2011 Regional Water Plan

Study 4

Water Quality Modeling of Regional Water Supply System to Enhance Water Quality and Improve Industrial Water Conservation

***Appendix E
TWDB Comments and
Summary of the Coastal Bend RWPG Responses***

Figure 3-1 Water Quality Sampling Points and Locations of USGS Gages in the Nueces River Basin

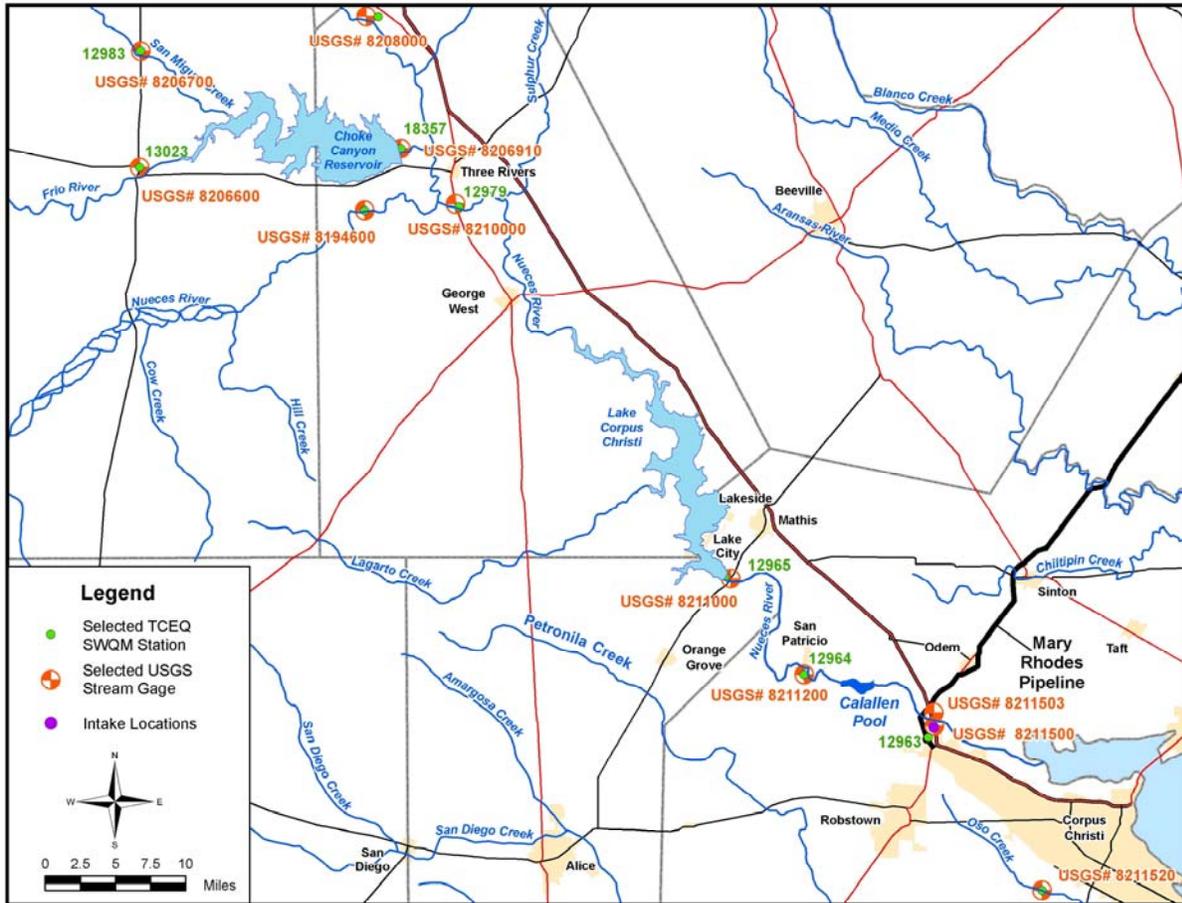
3. Pg. 3, Figure 3-1, suggest labeling Calallen Pool for reference.

Response: Added label per comment.
